PRAIRIE VILLA AT BEACON HILL

RE: SUB 2004-11 -- One-Step Final Plat of Prairie Villa at Beacon Hill Addition

At the regular meeting of the Subdivision Committee of the Metropolitan Area Planning Commission on Thursday, February 12, 2004, the above captioned plat was considered. The action of the Committee was to approve the one-step final plat, subject to the following staff comments:

CASE NUMBER: SUB 2004-11 -- PRAIRIE VILLA AT BEACON HILL ADDITION

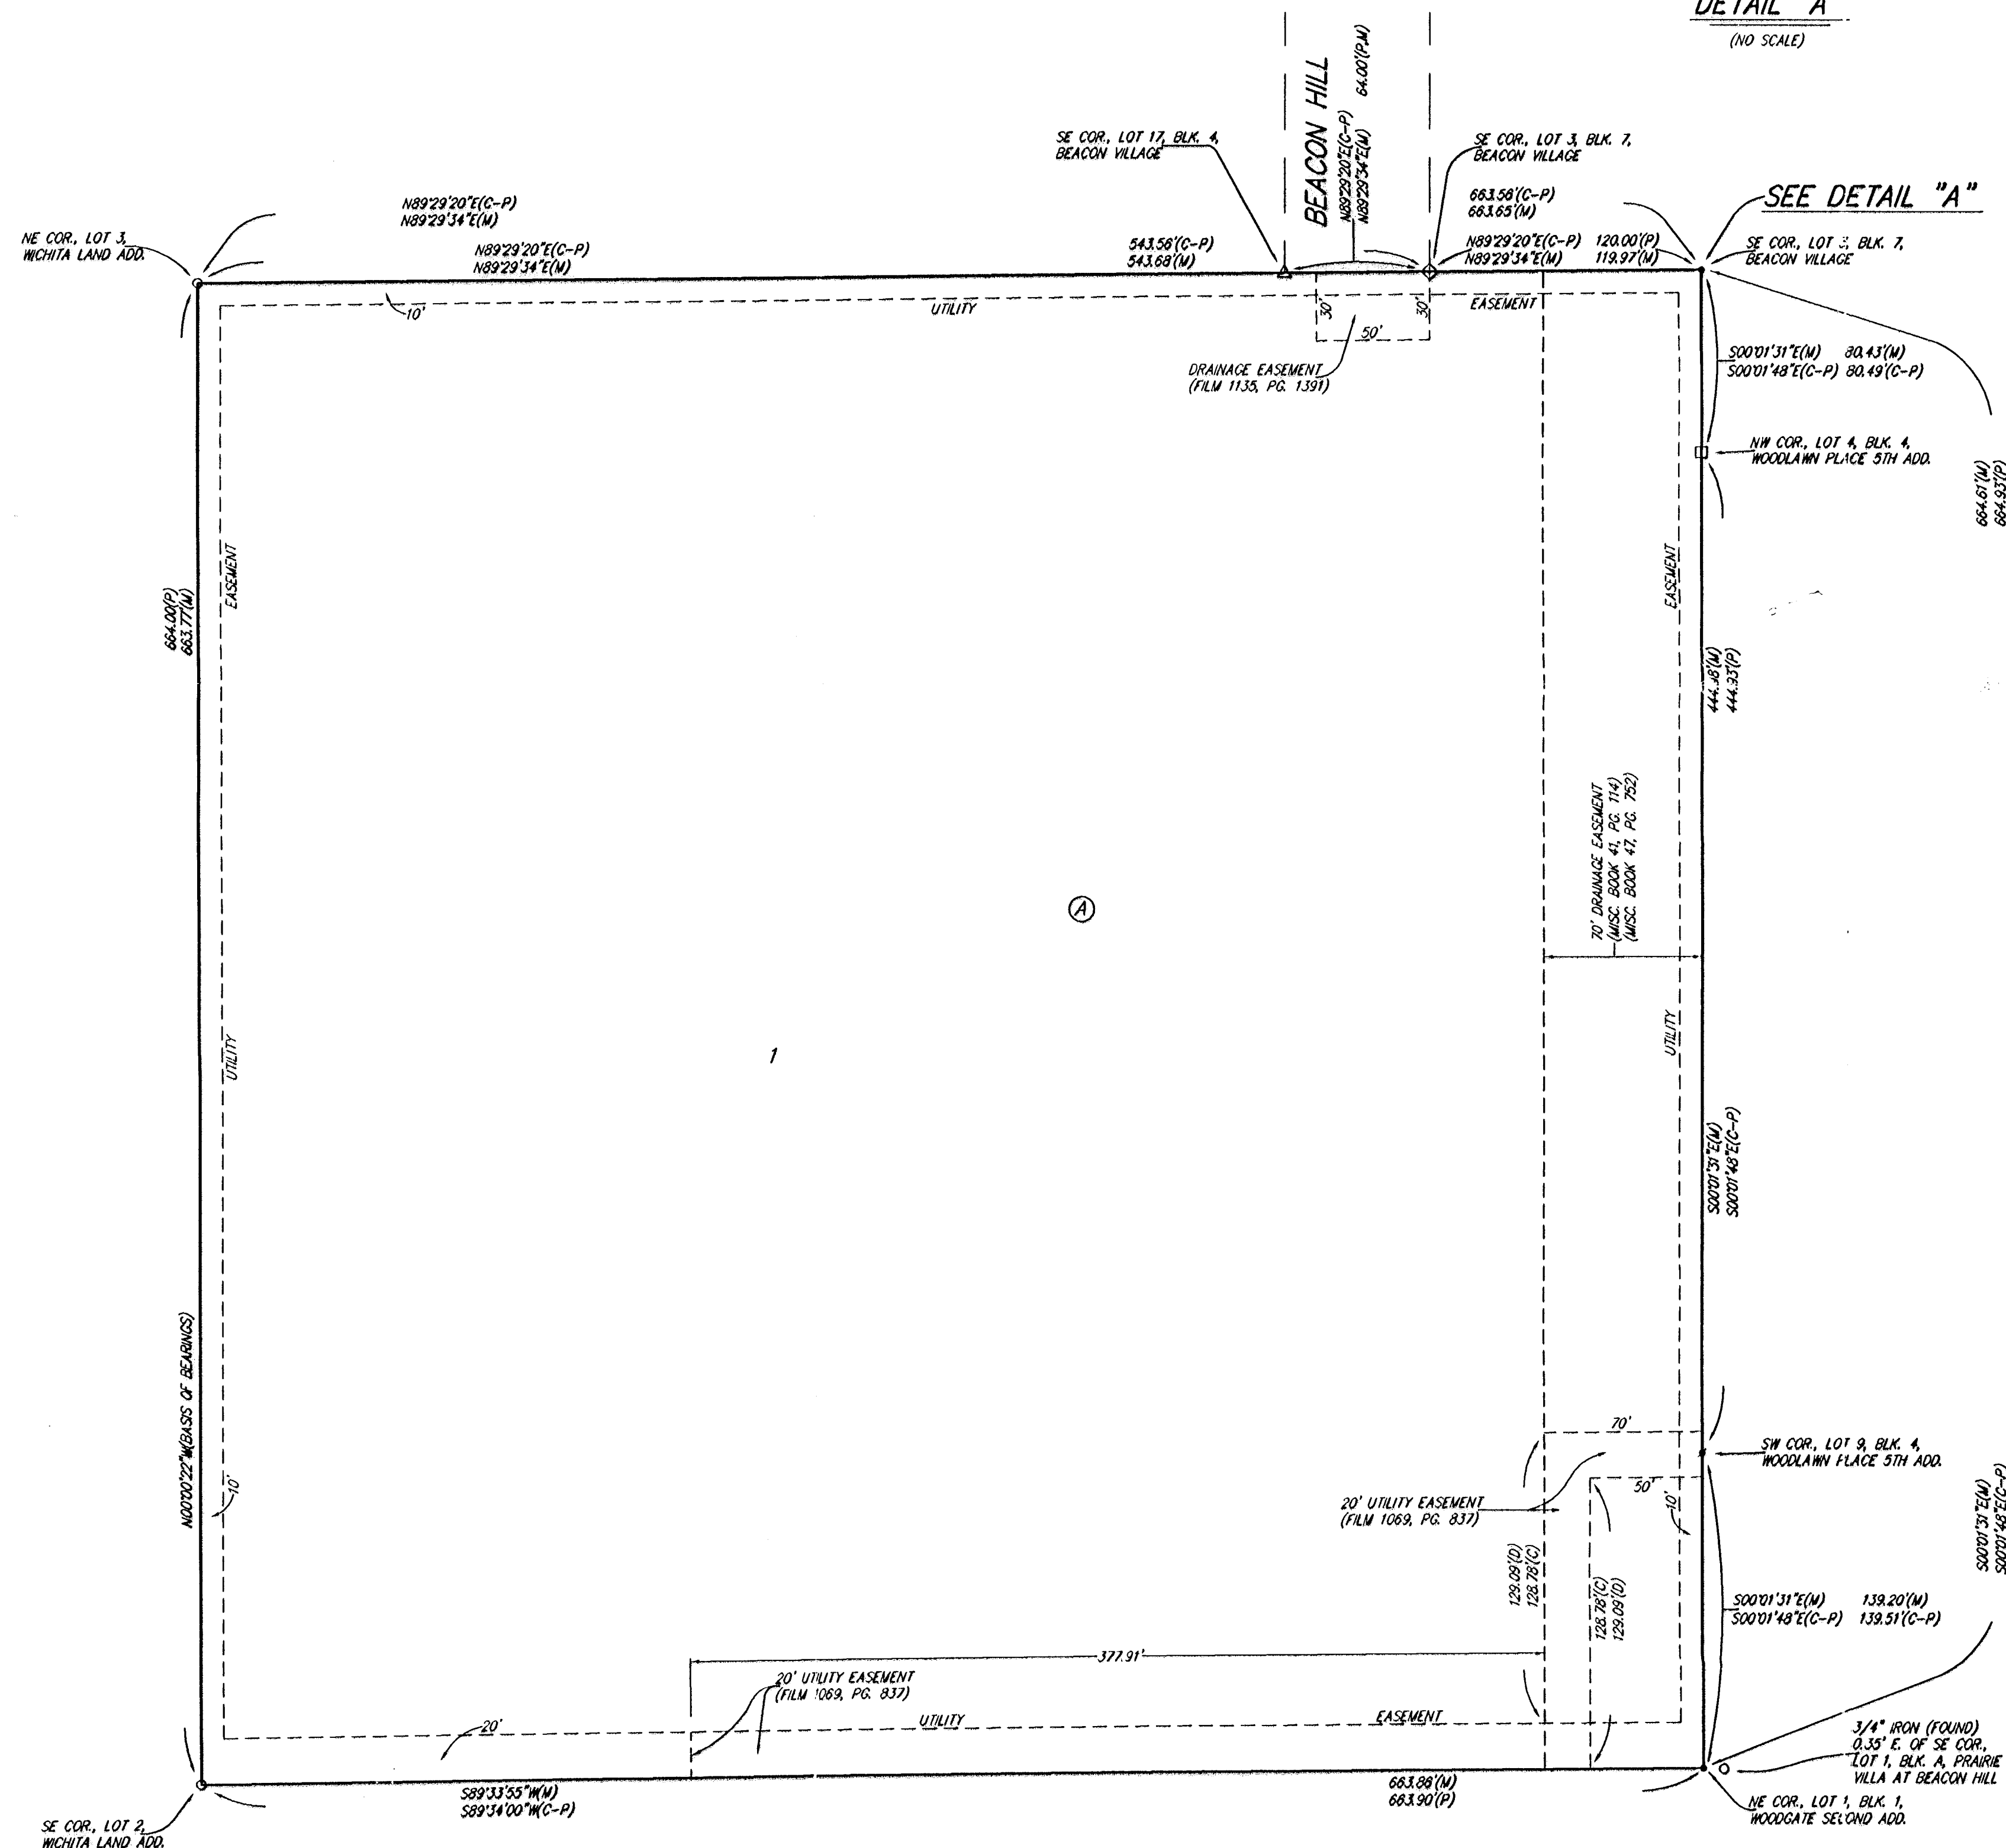
- A. Sanitary sewer is available to serve the site. The applicant shall guarantee the extension of City water to serve the lots being platted.
- B. If improvements are guaranteed by petition, a notarized certificate listing the petitions shall be submitted to the Planning Department for recording.

- C. City Engineering needs to comment on the status of the applicant's drainage plan. City Engineering has requested a drainage easement.
- D. City Fire Department needs to comment on the need for a turnaround. In lieu of a public right-of-way turnaround, a private drive circulation system is required with a 20-ft paved surface, 35-ft radius turnarounds or as approved by City Fire Department; and a 29-ft roadway at the entrance.

- F. The platator's text shall include language that a drainage plan has been developed for the plat and that all drainage easements, rights-of-way, or reserves shall remain at established grades or as modified with the approval of the applicable City or County Engineer, and unobstructed to allow for the conveyance of stormwater.

NOTE:
A DRAINAGE PLAN HAS BEEN DEVELOPED FOR THIS SUBDIVISION AND IS ON FILE WITH THE CITY OF WICHITA, KANSAS. DRAINAGE INTENT SHALL REMAIN AS DEPICTED OR AS MODIFIED WITH THE APPROVAL OF THE CITY ENGINEER OF THE CITY OF WICHITA, KANSAS. NO OBSTRUCTIONS WHICH IMPEDE THE FLOW OF THIS DRAINAGE PLAN SHALL BE ALLOWED.
